ADDENDUM NO. 1

- FROM: City of Grand Junction Purchasing Division
- TO: All Offerors
- RE: RFP-4166-16-DH Design Services for City of Grand Junction Water Treatment Plant Filter Upgrade Project

12" CONC WALL
		ORADO / C
		133294 S
		WAL ENGINEE
	12-089	
7.1	DATE DRAWN:	ORCHARD MESA WATER TREATMENT PLANT
nc.	10-02-12	
	10-02-12 Drawn by:	ELECTRICAL RELOCATION PROJECT CITY OF GRAND JUNCTION, COLORADO

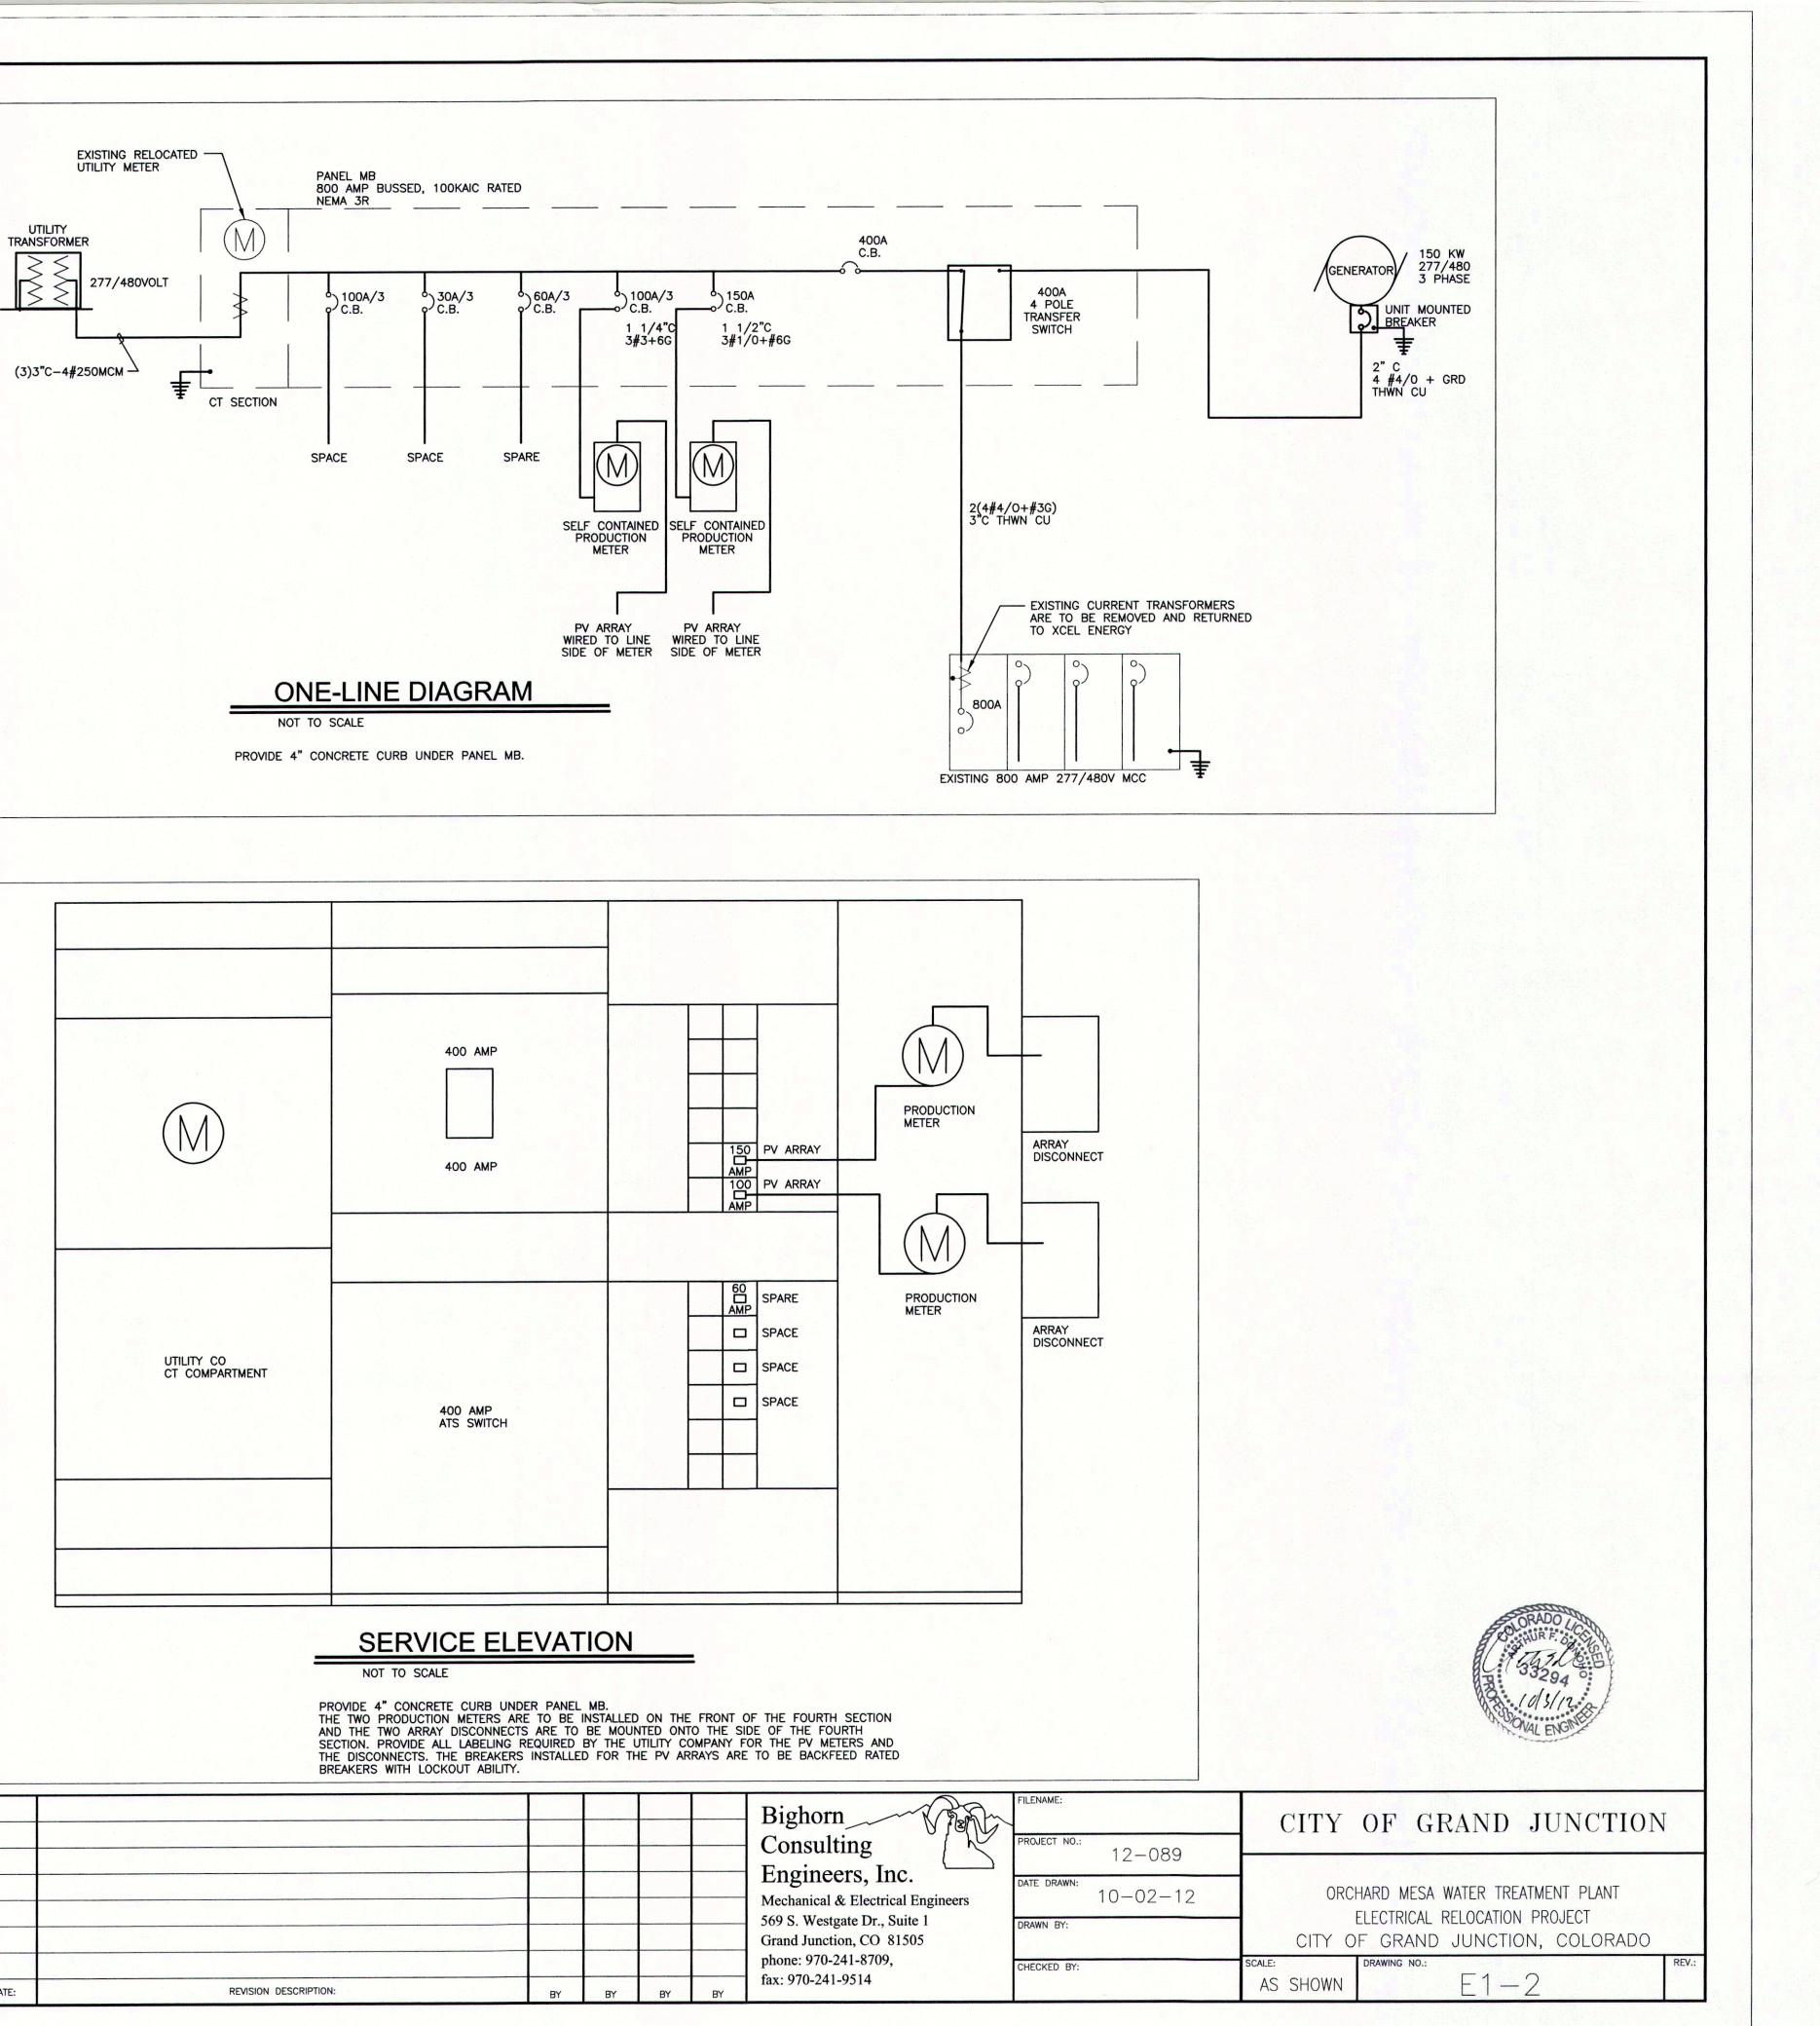
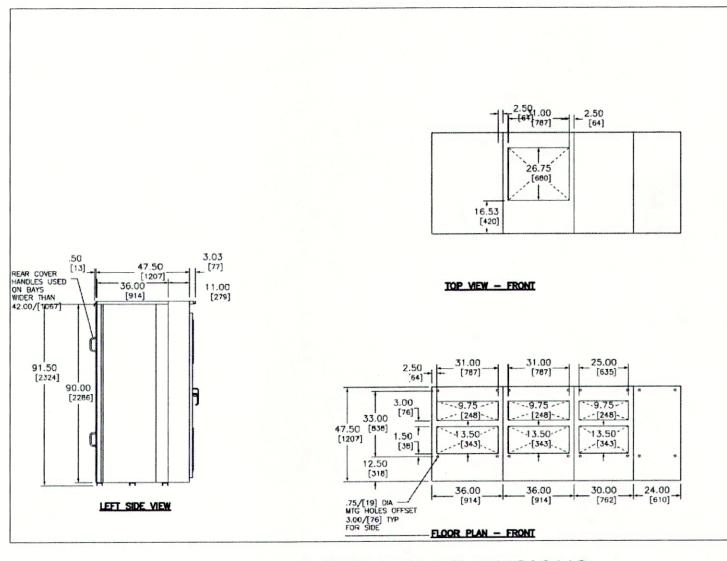
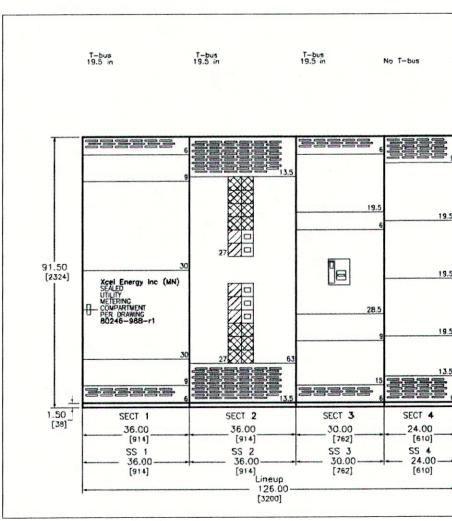
- 19. See attached one line diagrams is for the electrical service to the plant that was upgraded in 2013.
- 20.Q. Is a new service, meter and transformer expected to be required with this project? Can the existing MCC be used?

- A. A new electrical service may be needed to provide power for the blower(s). There is an existing 400 amp service in place.
